Re: Submittal Review – CJG Transport Outdoor Storage – Site Plan & Plat, Site Address: 2252 Tower Road, Lot 1, Block 1, Track Parts Subdivision Filing No. 2, Aurora, Adams County, Colorado 80011, Application Number: DA-2328-00

Below is a list of comments and applicable responses from the review of the Site Plan & Plat associated with case numbers: 2022-6056-00, 2022-3086-00.

SITE AND UTILITY PLAN

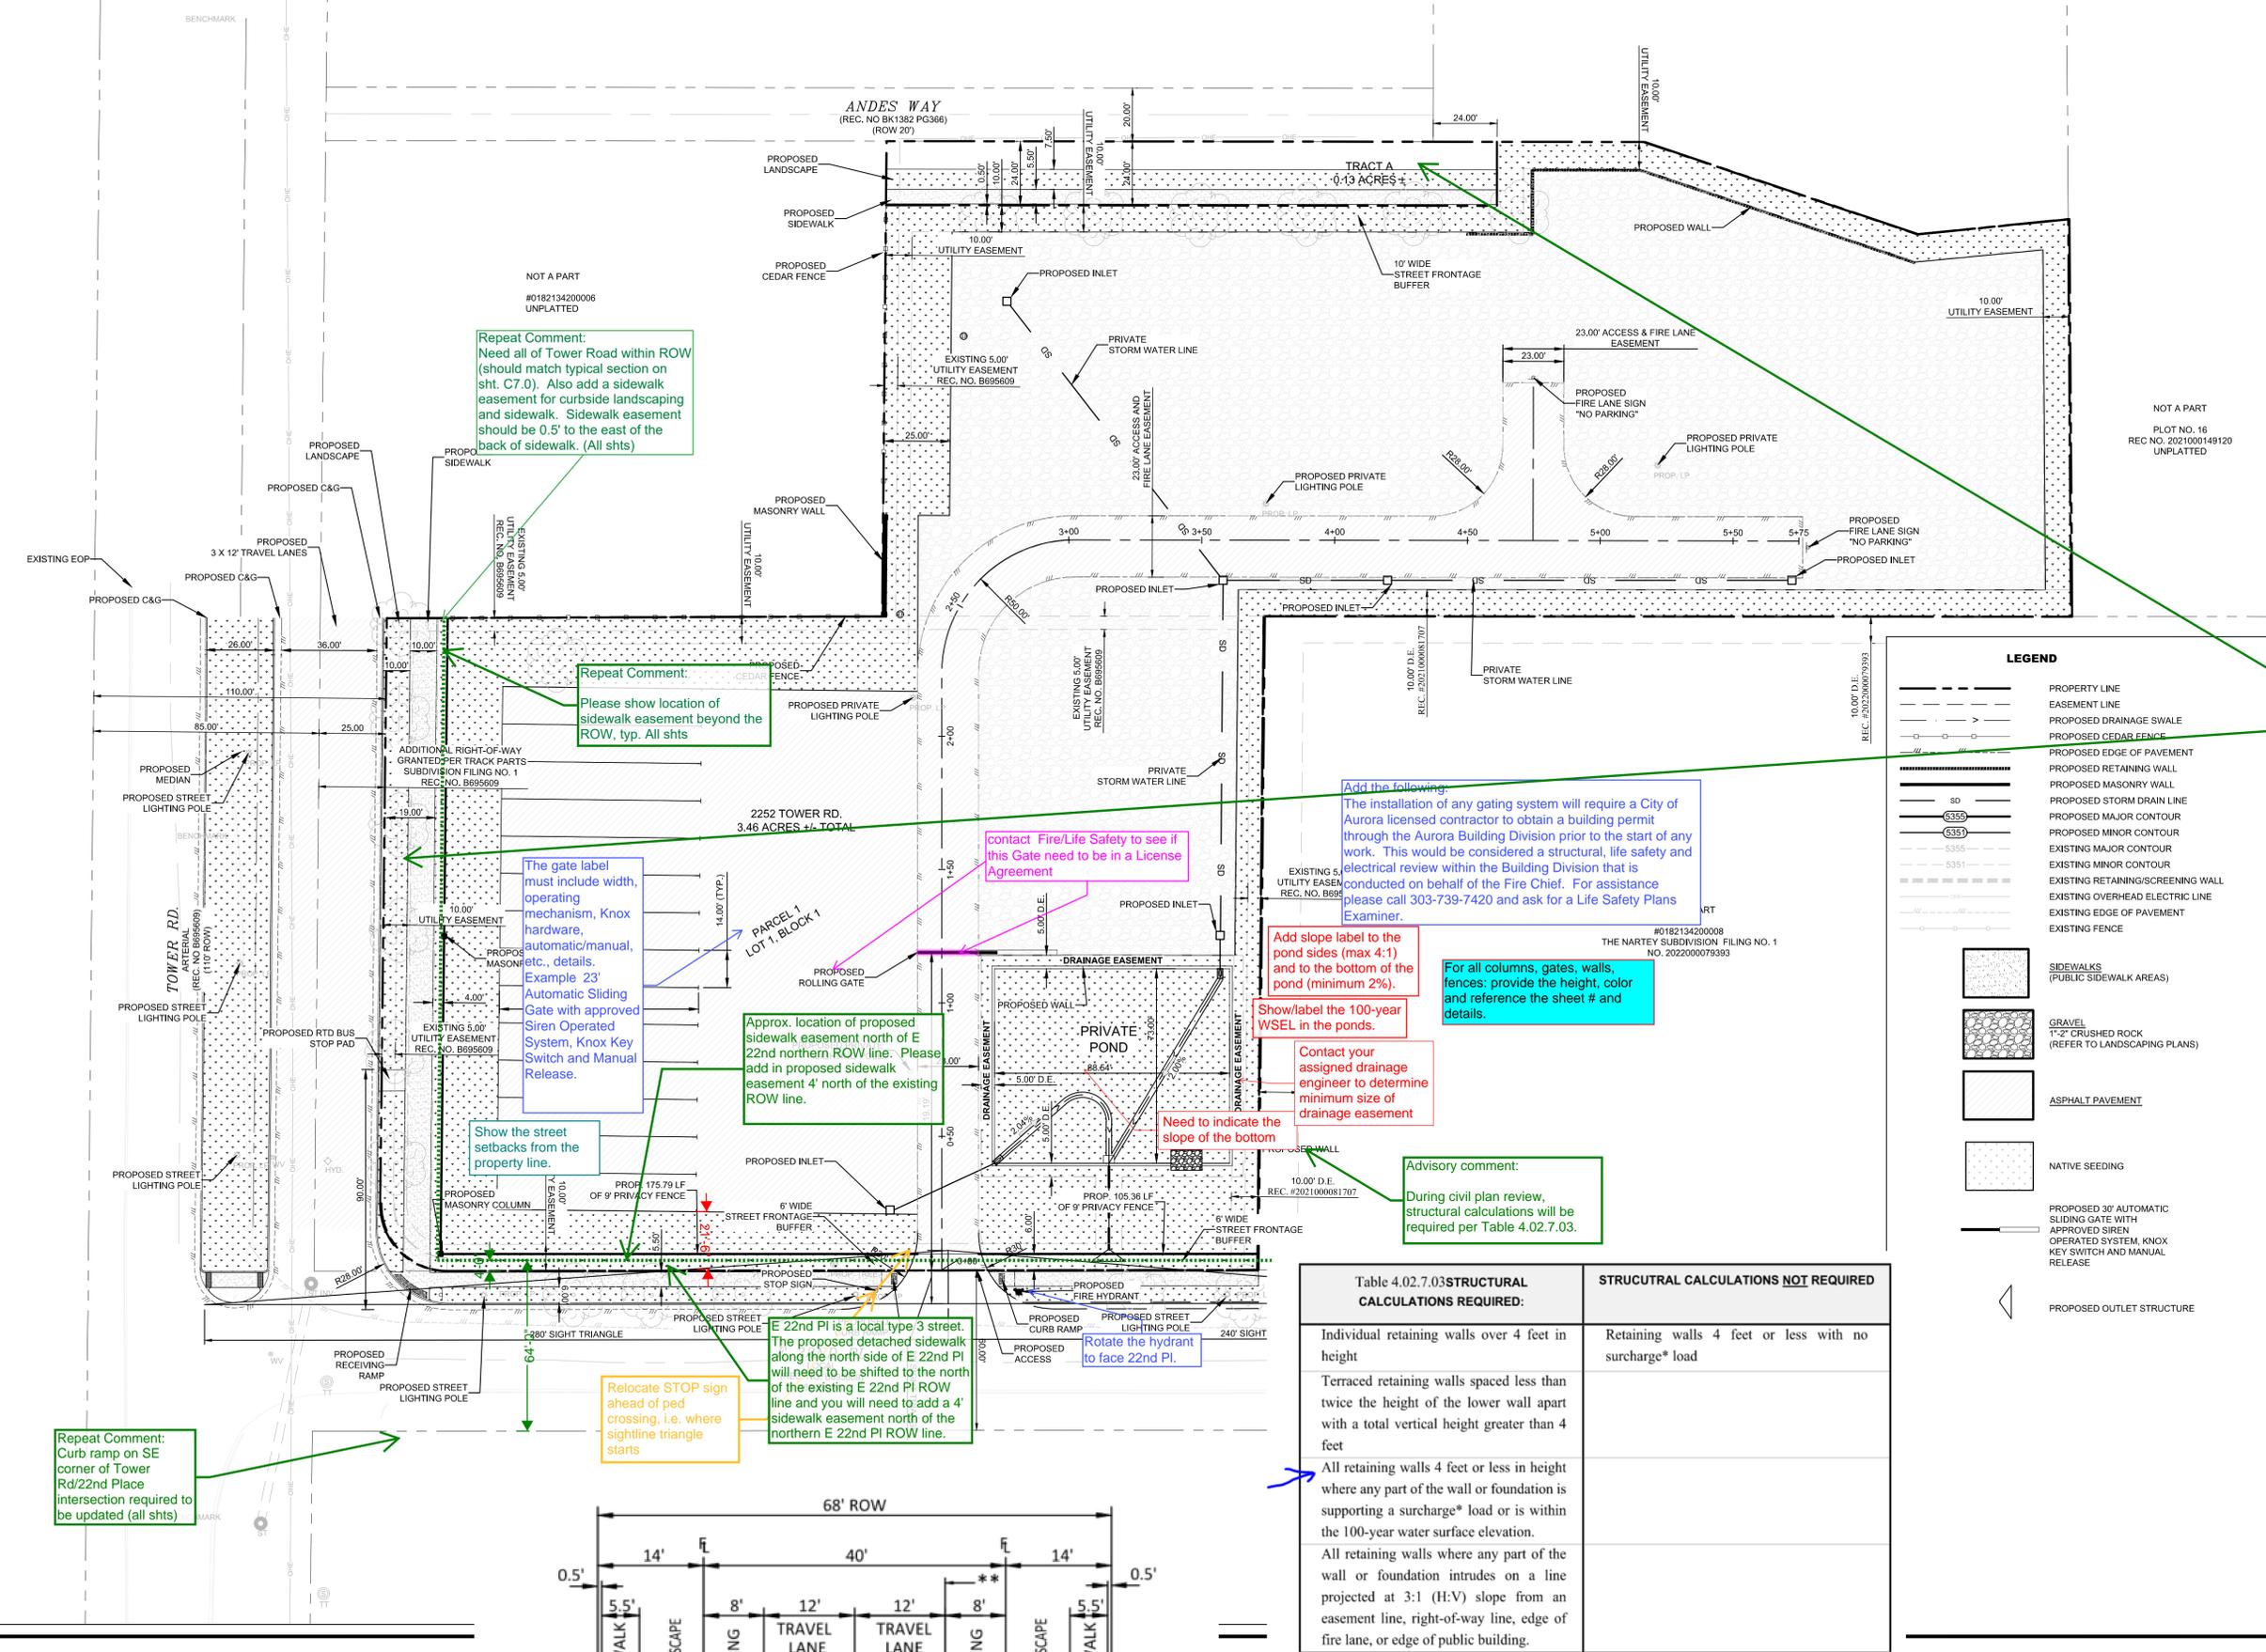
Repeat Comment:
Need all of Tower Road within ROW (should match typical section on sht. C7.0). Also add a sidewalk easement for curbside landscaping and sidewalk. Sidewalk easement should be 0.5' to the east of the back of sidewalk. (All shts)

Repeat Comment:
Please show location of sidewalk easement beyond the ROW, typ. All shts

Approx. location of proposed sidewalk easement north of E 22nd northern ROW line. Please add in proposed sidewalk easement 4' north of the existing ROW line.

Show the street setbacks from the property line.

E 22nd PI is a local type 3 street. The proposed detached sidewalk along the north side of E 22nd PI will need to be shifted to the north of the existing E 22nd PI ROW line and you will need to add a 4' sidewalk easement north of the northern E 22nd PI ROW line.

Repeat Comment:
Curb ramp on SE corner of Tower Rd/22nd Place intersection required to be updated (all shts)

Add the following:
The installation of any gating system will require a City of Aurora licensed contractor to obtain a building permit through the Aurora Building Division prior to the start of any work. This would be considered a structural, life safety and electrical review within the Building Division that is conducted on behalf of the Fire Chief. For assistance please call 303-739-7420 and ask for a Life Safety Plans Examiner.

Add slope label to the pond sides (max 4:1) and to the bottom of the pond (minimum 2%).

For all columns, gates, walls, fences: provide the height, color and reference the sheet # and details.

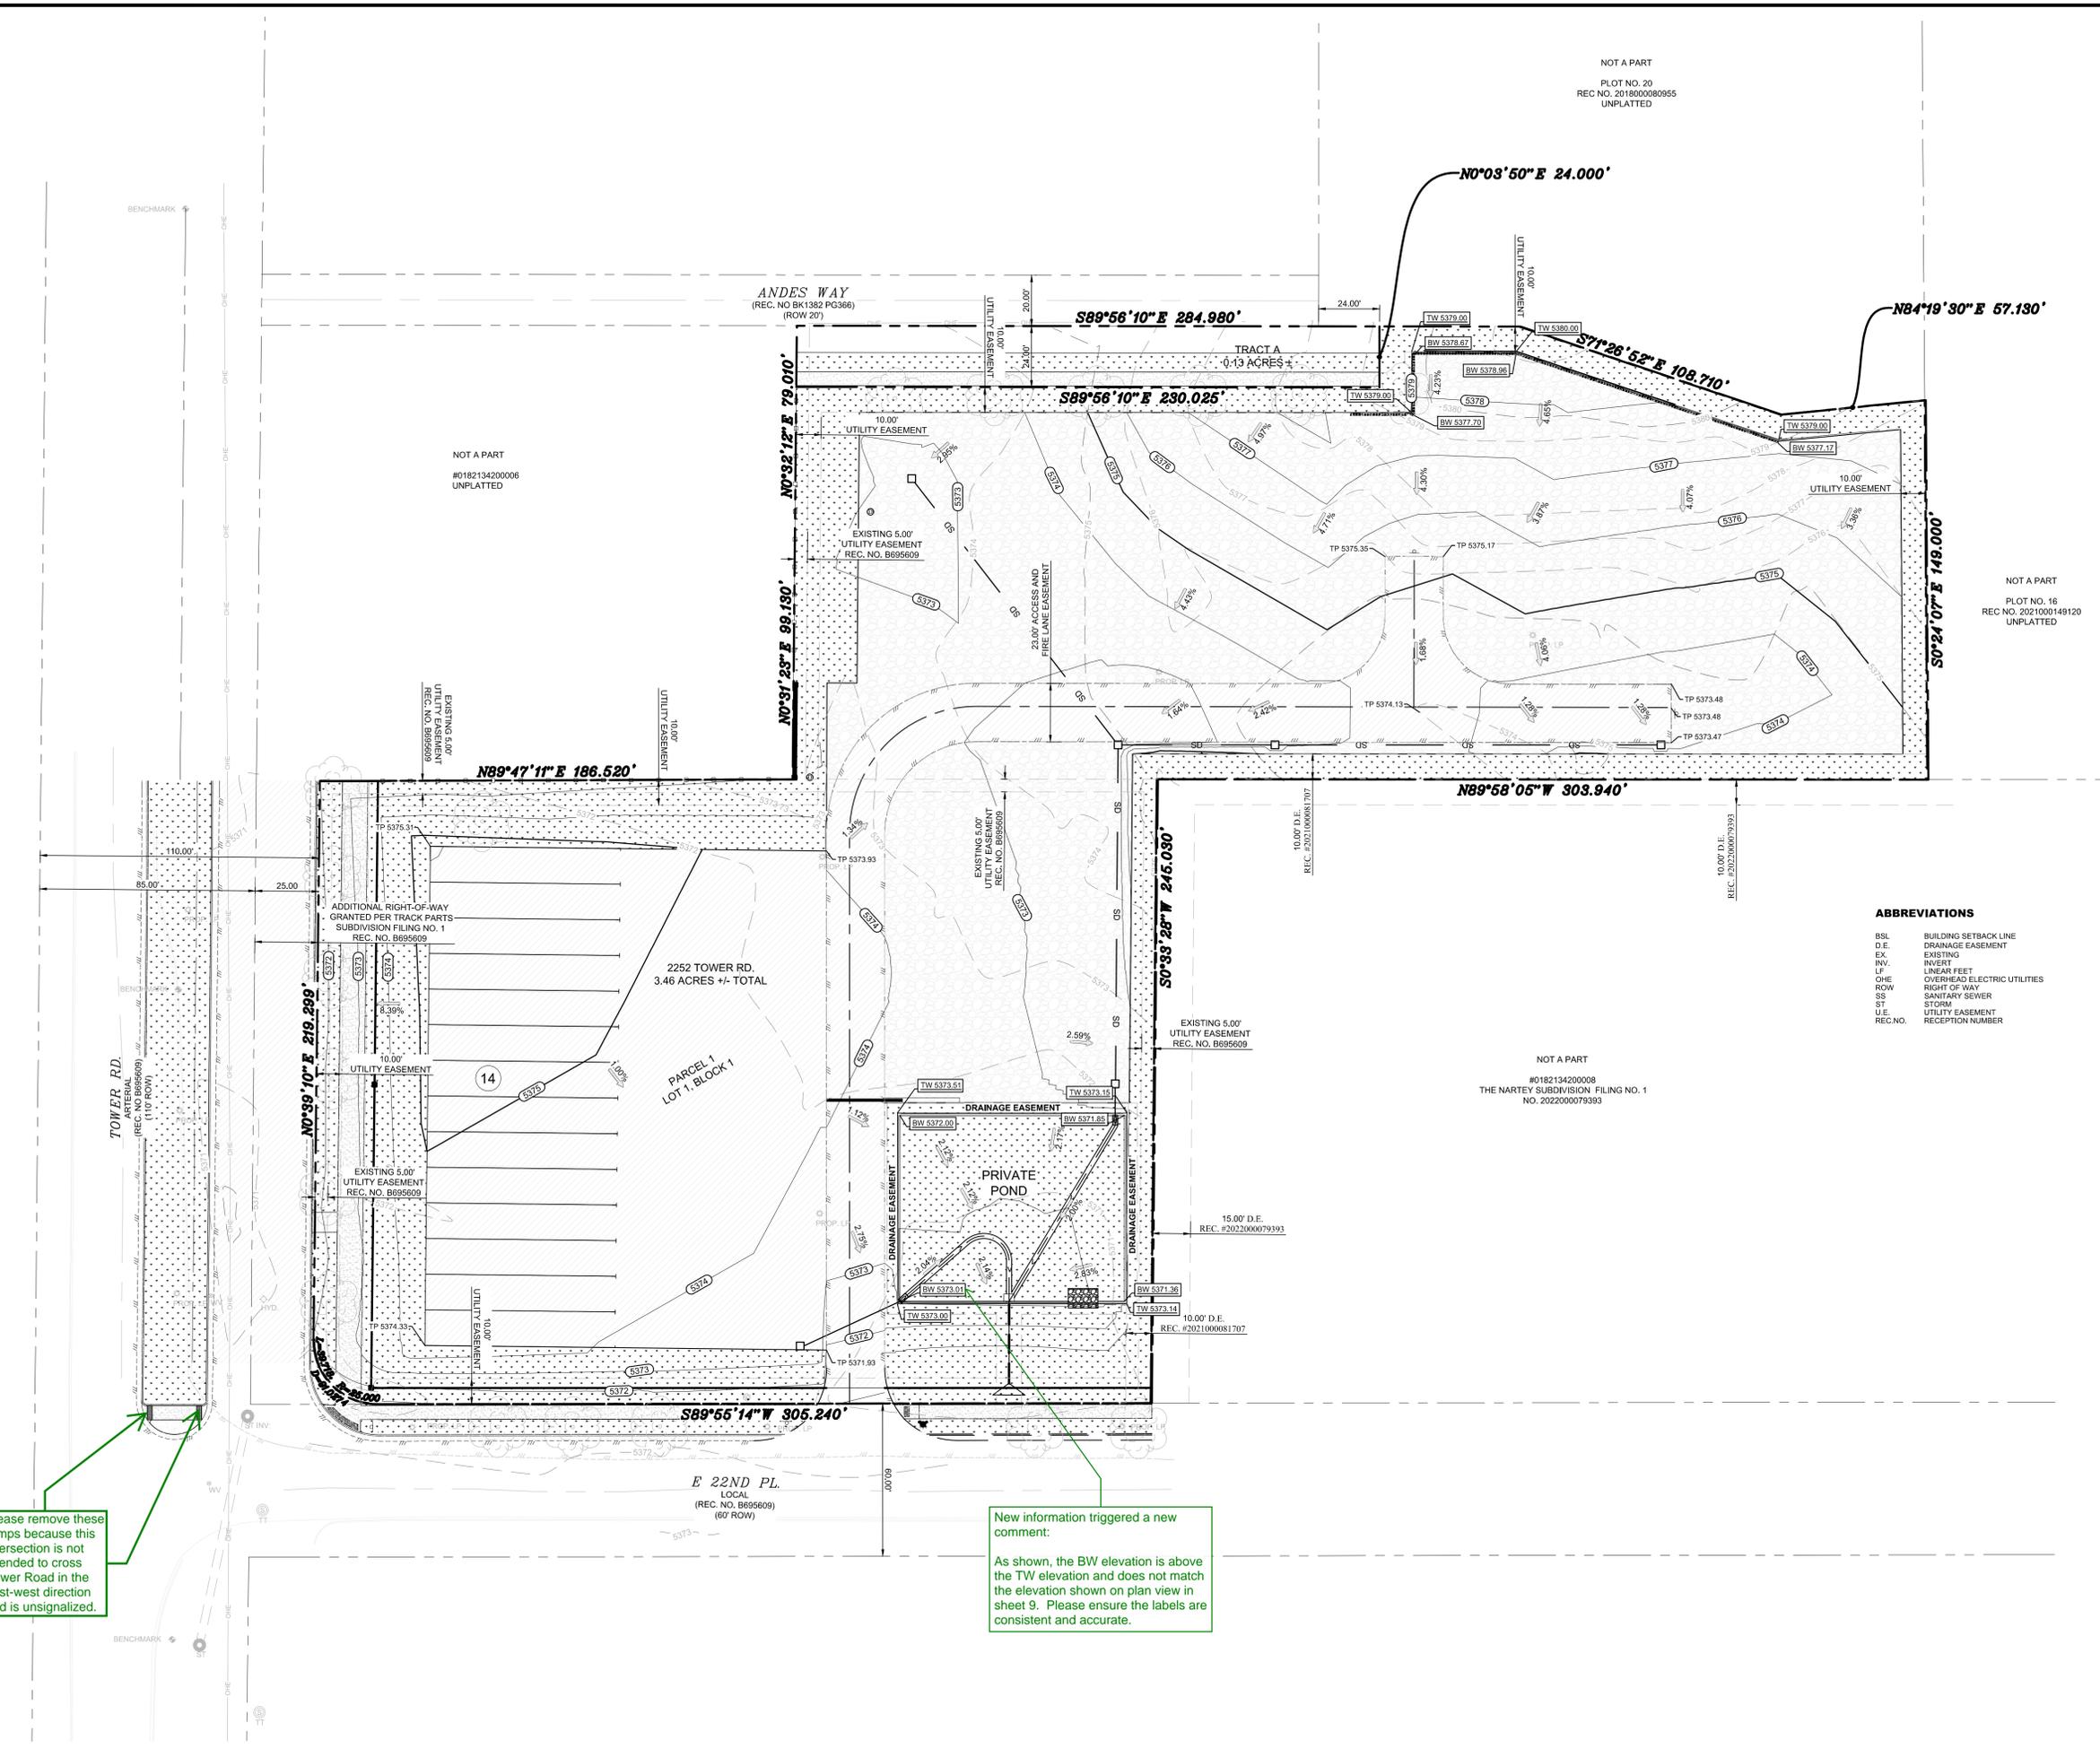
Advisory comment:
During civil plan review, structural calculations will be required per Table 4.02.7.03.

Please remove these ramps because this intersection is not intended to cross Tower Road in the east-west direction and is unsignalized.

New information triggered a new comment:
 As shown, the BW elevation is above the TW elevation and does not match the elevation shown on plan view in sheet 9. Please ensure the labels are consistent and accurate.

L 1.0

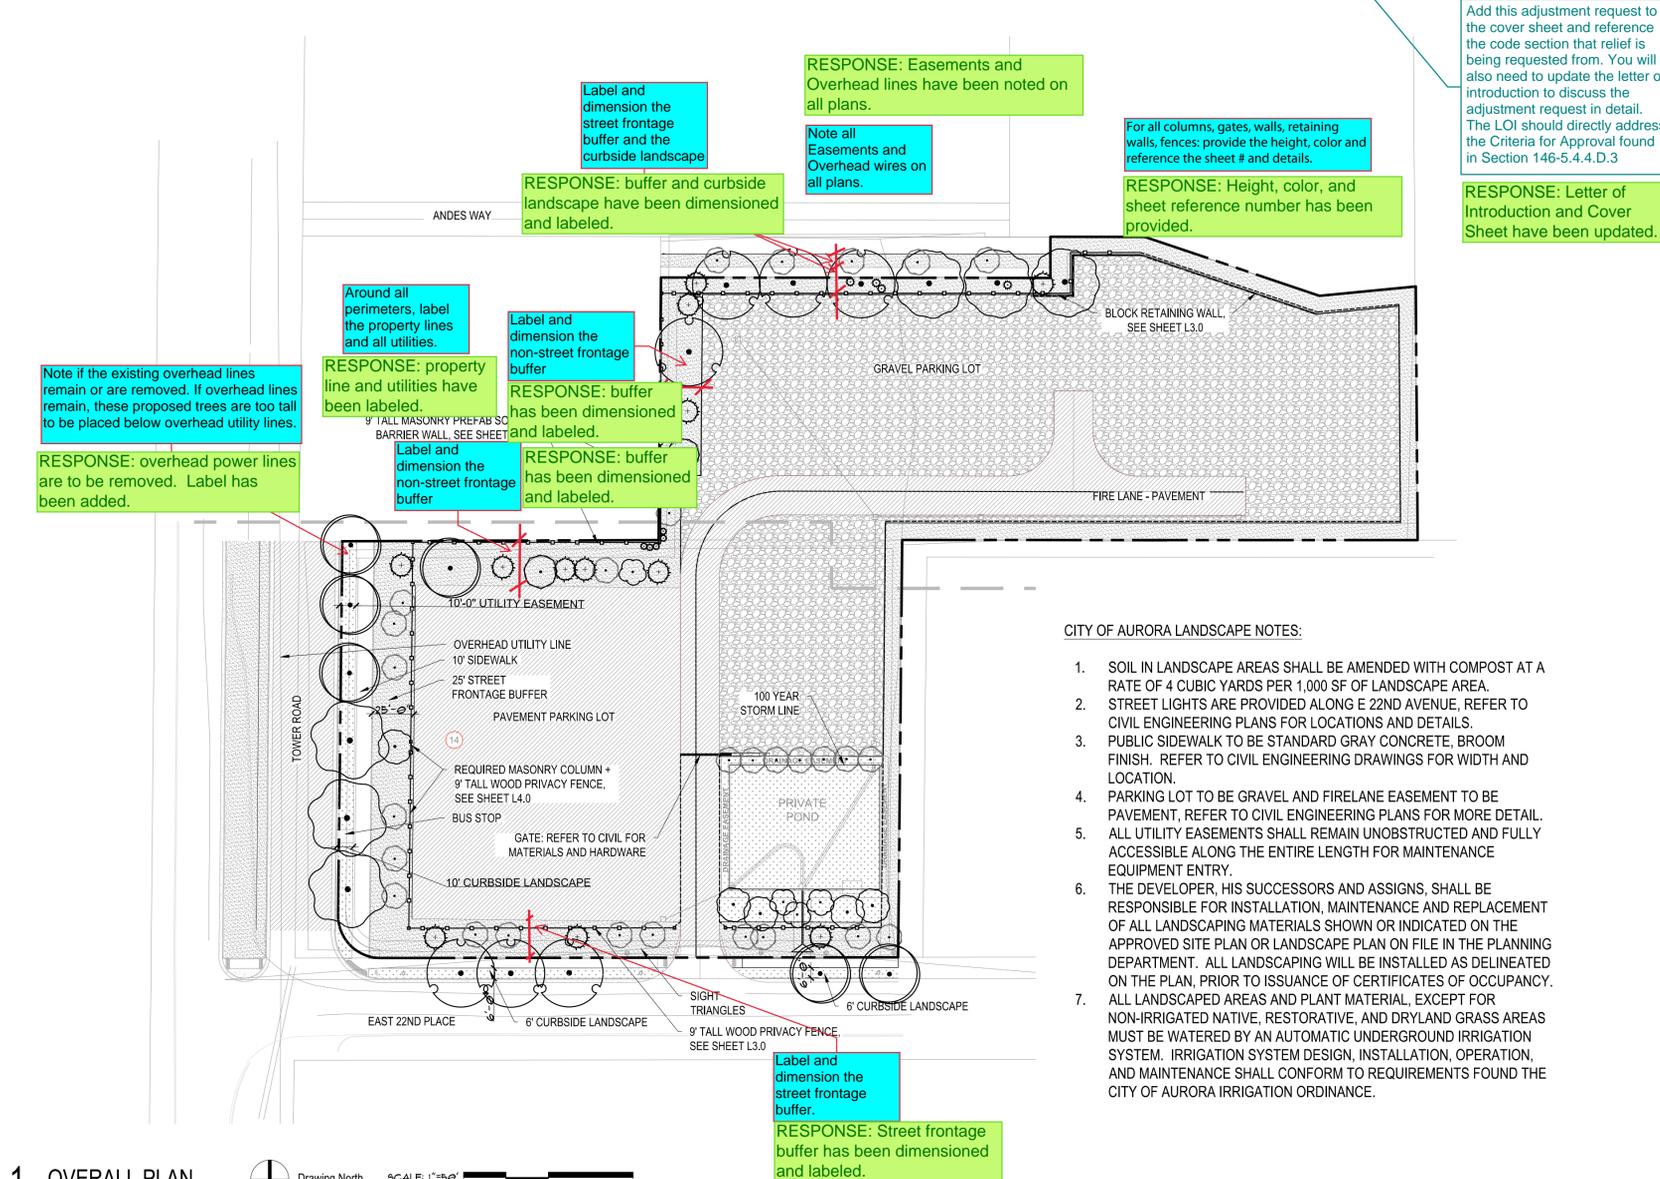
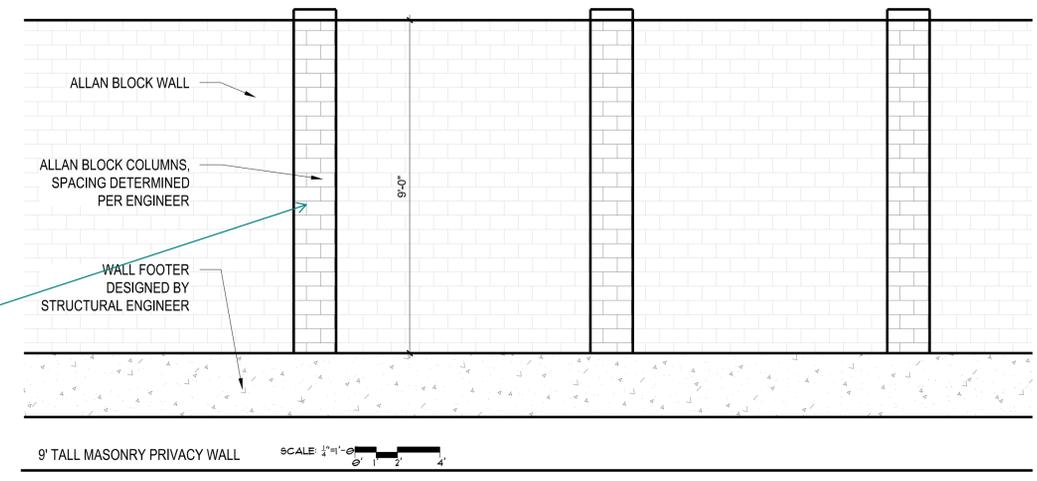
Dimension the masonry columns. They are required to have an 18"x18" cross section along arterial and collector roads.

Note the colors and heights for each detail if not shown.

RESPONSE: Noted, dimension has been added.

RESPONSE: Color and Height has been identified for all details.

**ELEVATION VIEW ALUMINUM CANTILEVER GATE
OUTSIDE LOOKING IN**

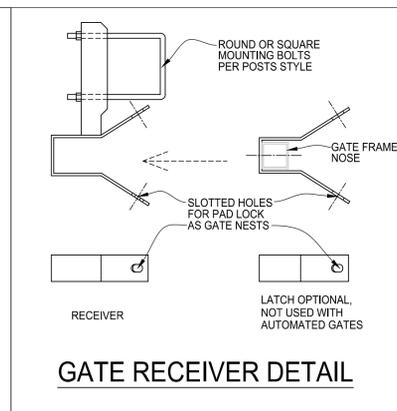
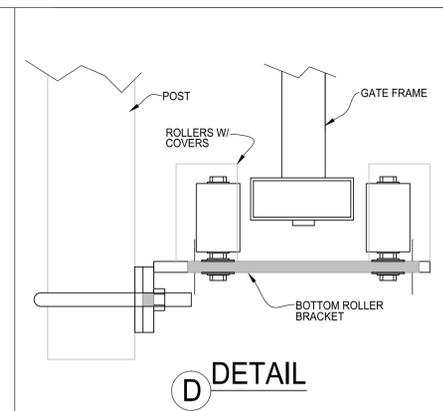
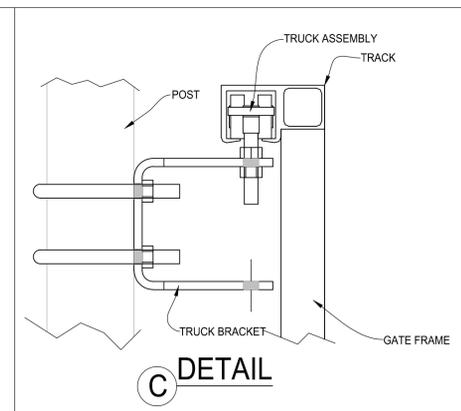
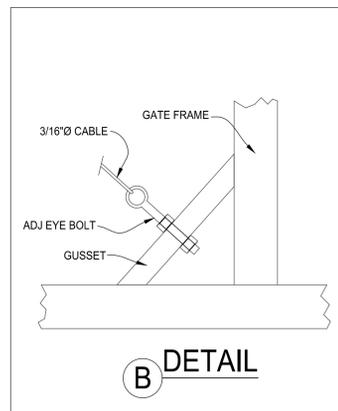
Identify and label proposed gate.
Example 23' Automatic Sliding Gate with approved Siren Operated System, Knox Key Switch and Manual Release.
ELECTRONIC GATING SYSTEMS SHALL INCLUDE AN EMERGENCY VEHICLE GATE OPENING SYSTEM UTILIZING A REDUNDANCY BACK-UP SYSTEM THAT CONSISTS OF A SIREN OPERATED SYSTEM, AN AUTOMATIC KNOX KEY SWITCH AND A MANUAL OVERRIDE
